TLE986xQX Family - BE-Step
TLE987xQX Family - BE-Step

Overview

This document lists the errata of the TLE986xQX family and the TLE987xQX family, for related products please refere to **Table 2**.

Figure 1 Example IRAM settings for the TLE9871QXA20

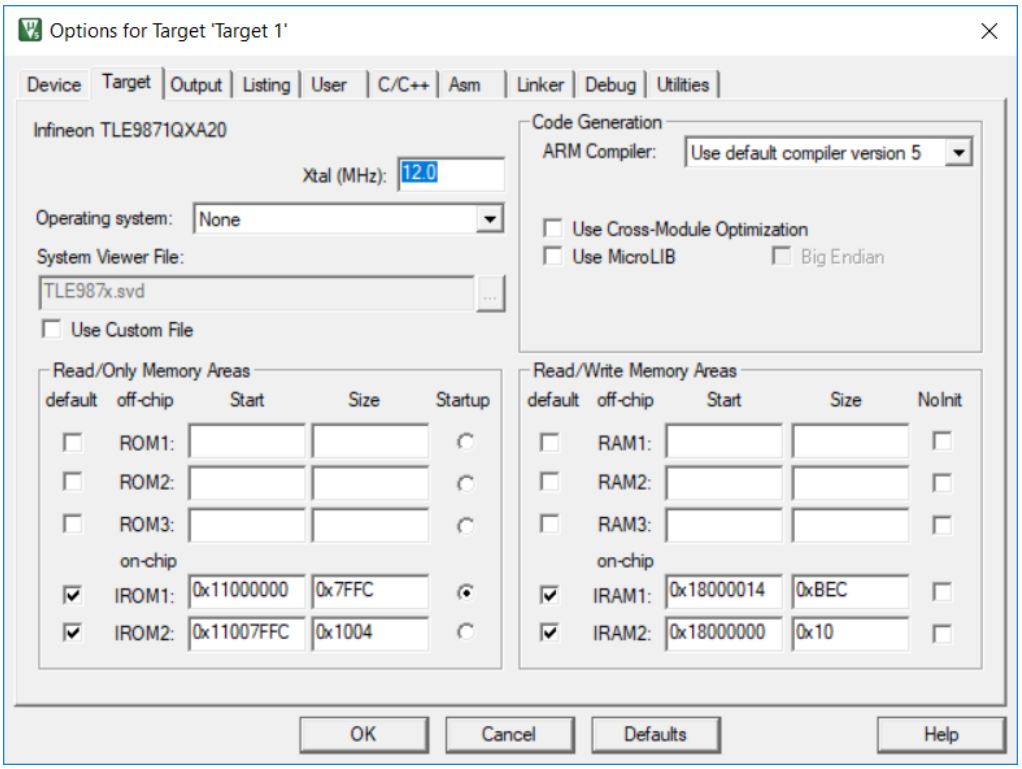
The function USER_NVM_ECC_CHECK uses for its operation 32 bytes on the user stack plus 1 byte in user RAM at address 0x18000011, this is not clearly specified in the BootROM User Manual.

Adjust the project IRAM settings to exclude this address from the RAM area usable by the linker. In order to maintain memory alignment a hole of four bytes, from 0x18000010 to 0x18000013 is recommended. **Figure 1** displays an example for the TLE9871QXA20. **Table 3** lists the recommended IRAM settings for each device.

Figure 5 Register view of implemented SHPR2 register

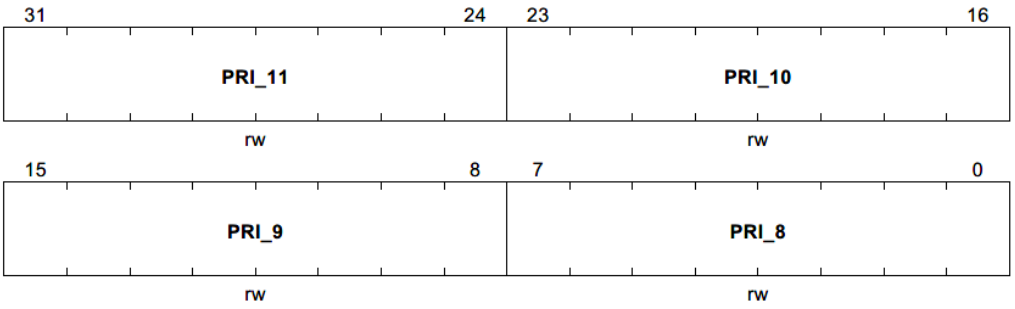
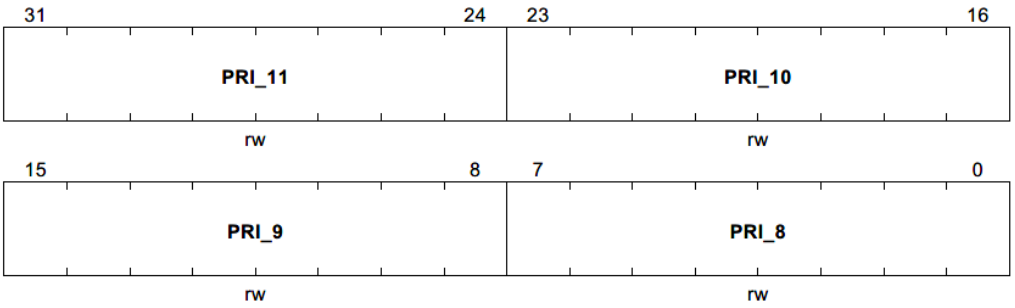
The address of the register SHPR2 is specified wrongly.

The imlemented address for the register SHPR2 is 0xE000ED1C.
